SUBJECT: INTERIM PLUGGING CRITERIA FOR TROJAN NUCLEAR PLANT

Discussion of Technical Rationale for Steam Generator Tube Interim Plugging Criteria (IPC) at The Trojan Nuclear Plant

Figure 1 - Burst Pressure Parameter Curves for EDM Slot and Uniform Thinning Specimens

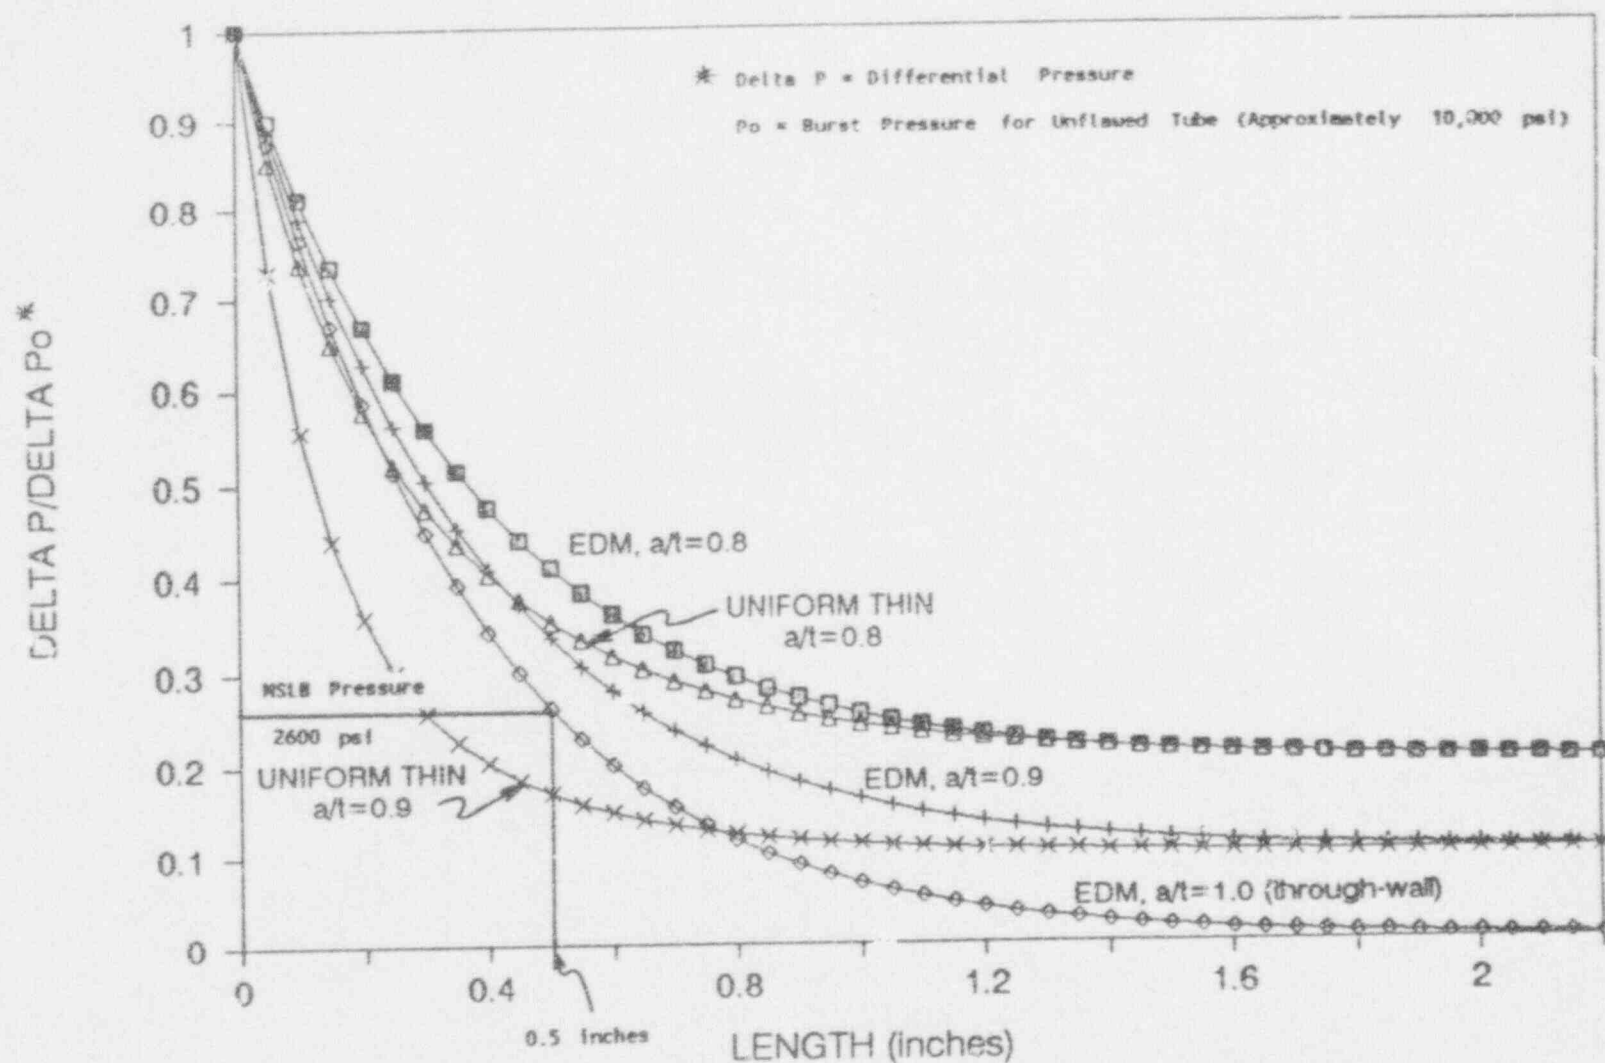
(3) Steam Generator Tube Burst Test Results: Burst test results on tubes removed from the Trojan steam generators showed no leakage under normal operating or MSLB pressures.¹ When pressurized to failure, the burst pressures measured for the tubes were in excess of the MSLB pressure by at least a factor of two. NRC research results from burst tests of tubes with machined, chemically-induced and service-produced defects have also provided a significant body of data on tube integrity. Equations which have been fitted to the burst test data for electric discharge machined (EDM) slots in steam generator tubes have shown that 0.5 inches would be the length of through-wall crack that would be expected to burst at MSLB pressures for 7/8-inch diameter, 0.050 inch wall thickness tubing² (see Figure 1). The equation for the through-wall EDM slot represents an extrapolation from data measured on up to 90% through-wall slots. NRC research has shown that the empirical equation developed from EDM slots provides a realistic estimate of remaining margin to failure for tubes with stress corrosion cracks.³ An empirical equation fitted to data from burst tests of uniformly thinned steam generator tubes has also been developed.² This equation is contrasted with the EDM equation in Figure 1. It can be seen that the two equations are of similar form but that the uniform thinning equation provides more conservative estimates of tube burst pressures for flaw depths greater than a/t of 0.8, where a = flaw depth and t = tube wall thickness. Use of either equation to bound degradation up to a/t of 0.8 should yield similar results in terms of burst pressure. However, the EDM equation provides a more accurate representation of stress corrosion cracking and should be used for flaw depths greater than $a/t = 0.8$.
